TO: Mercedes-Benz Dealer Principals, General Managers, Sales Managers, Service Managers, Parts Managers	FROM: Gregory Gunther, Department Manager, Vehicle Compliance and Analysis, Engineering Services
RE: Emission Modification Notification – [[2020050025]] MY 12 R350 BlueTec 4MATIC Update – Emission Modification Category (EMC) #5	DATE: May 27, 2022

Campaign No. 2020050025, January 2022

SUBJECT: **Model R-Class diesel vehicles (V251 platform)**
Model Year 2012
Modification to the emission control system

Figure 4

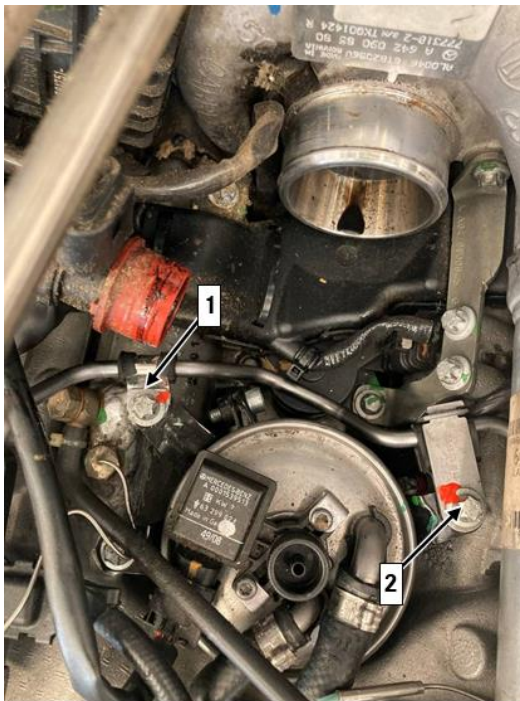
i The line from the left fuel distributor to the right fuel distributor is replaced by a new version (A 642 070 09 00) (Figure 4). A new clamp (1, Figure 4, (N 000000 006288)) with new bolt (2, Figure 4, (N 000000 001116 M6x19mm)). The old bracket on position (2, Figure 4) is reused and with a new bolt (N 000000 001114 M6x15mm) fastened. The old bracket must be reinstalled as shown. Chafe-free routing must be ensured.

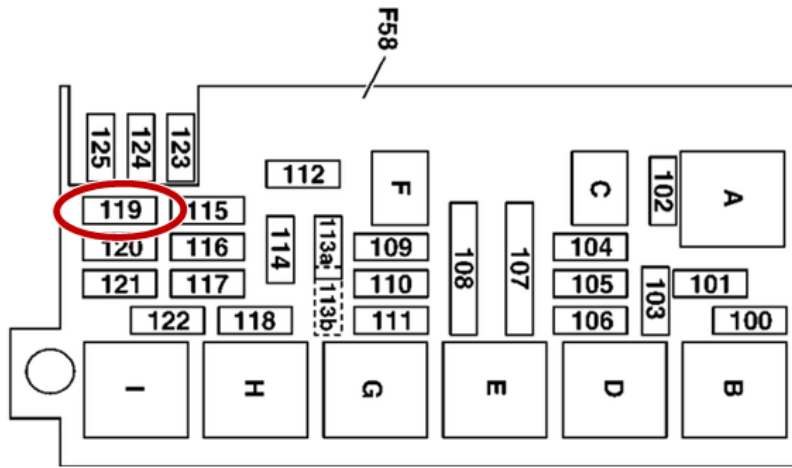
8. Check fuse **F119** for presence in the fuse and relay box (F58) in the engine compartment on the right and remove if necessary.

i If this fuse is plugged in, it must be removed before the software update. The fuse must not be plugged in again and has to be disposed.

Figure 6

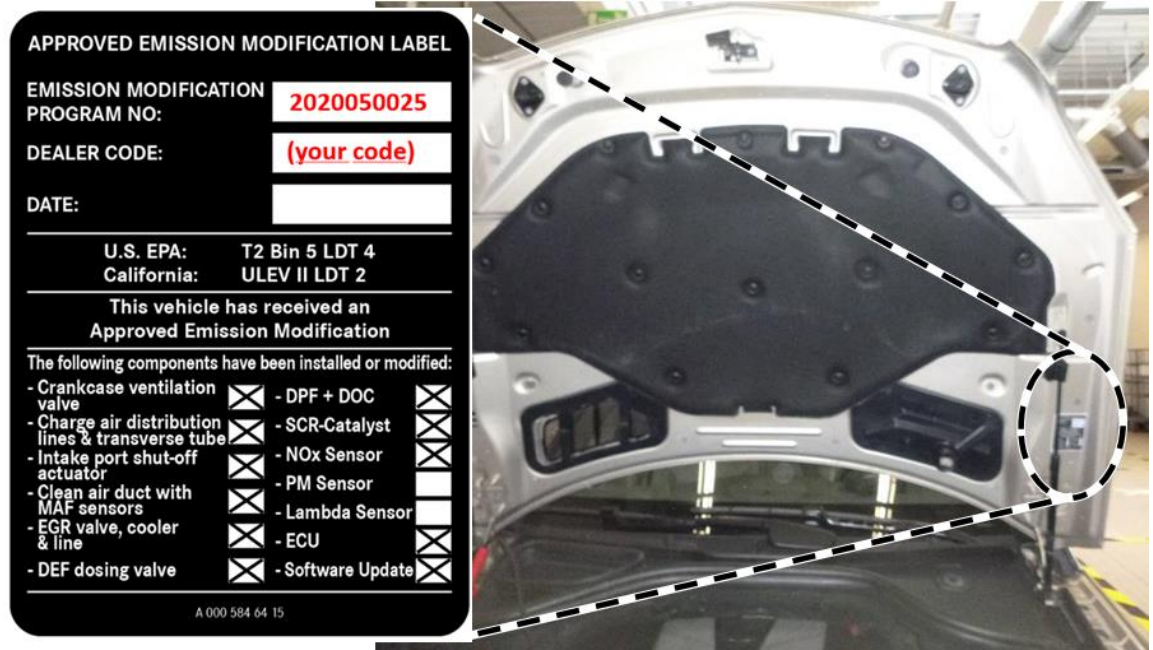
12. Clean the bonding surface of the hood and attach the adhesive label (A 000 584 64 15) (Figure 6).

i The fields on the adhesive label must be filled out correctly. Please use black permanent marker. Refer to (Figure 6) within the XENTRY procedure.
